Re: Docket No. 508 - The United Illuminating Company Application for a Certificate of Environmental Compatibility and Public Need for the Milvon to West River Railroad Transmission Line 115-kV Rebuild Project

Enclosed for filing with the Connecticut Siting Council ("Council") are The United Illuminating Company's responses to the City of Milford's April 26, 2022 interrogatories ("Set 1").

The United Illuminating Company
Docket No. 508

Figure 2

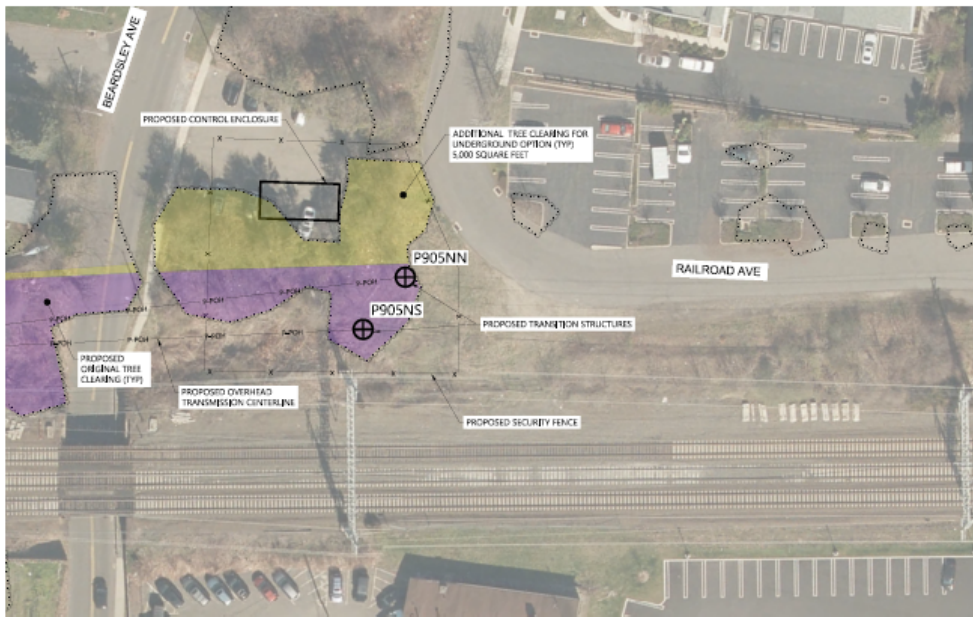
(h) Provide details of the visual impact of “transition stations” including their size and height as compared to the proposed monopoles.

- (h) An overhead-to-underground-to-overhead configuration will require the installation of four riser structures, one structure per circuit, located at each end of the underground cable section. These are where the overhead wires will connect to the underground cables. To accommodate the overhead wire clearances, the heights of the poles that are currently proposed at the riser pole locations (P905: 115' and P914: 135') would not change, and two underground cables per phase, for a total of 12 cables, would need to be installed to match power flow of the overhead wires. Underground cables would be connected to other electrical equipment (i.e. substation bus, overhead wire) through cable terminations. To accommodate the connection of the overhead wires to the underground cables, these terminations would need to be installed on the riser structure arms (see Figure 1 below for a representative illustration of a riser structure).

In addition, the underground configuration would also require one transition station, which would be located at one end of the underground transmission cable segment. This transition station would include two of the four riser structures as well as one control enclosure (approximately 30 feet long, 14 feet wide and 12 feet tall) for protection and control equipment for safe and reliable operation of the underground cables. The estimated size of the transition station would be $\sim\frac{1}{4}$ acre.
